Central Waste Plant Resource Recovery Facility (SSD-10435)

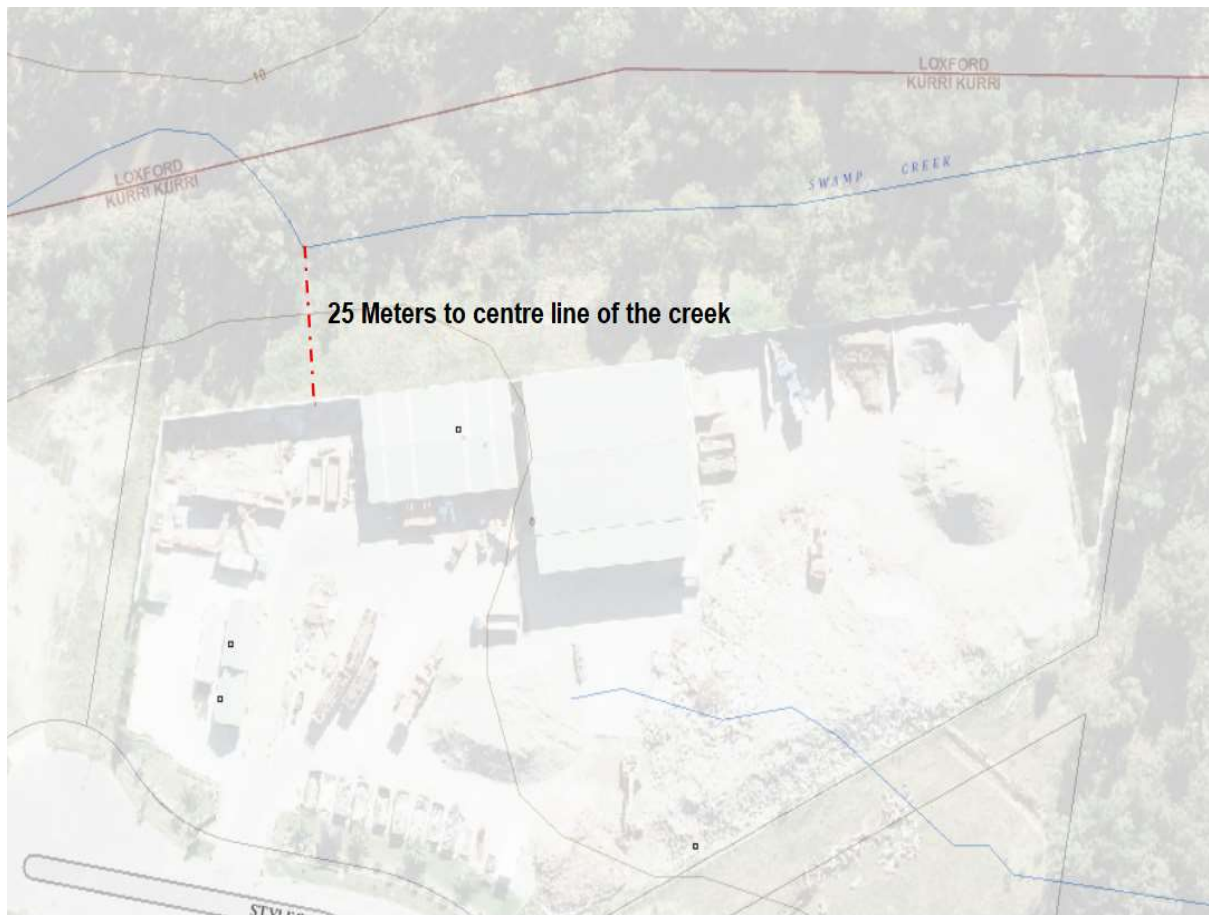
Development sits within riparian zone and developer is also developing further into the riparian zone with this application.

The GEM report also incorrectly states there will be no further development north towards the creek.

The following map shows the existing development is 25 meters from the creek centre line, the NSW guidelines call for the riparian zone to start from the top of the

From the aerial photo and the riparian guidelines it is quite clear the existing development sits well within the riparian zone and is in breach of the NSW water guidelines.
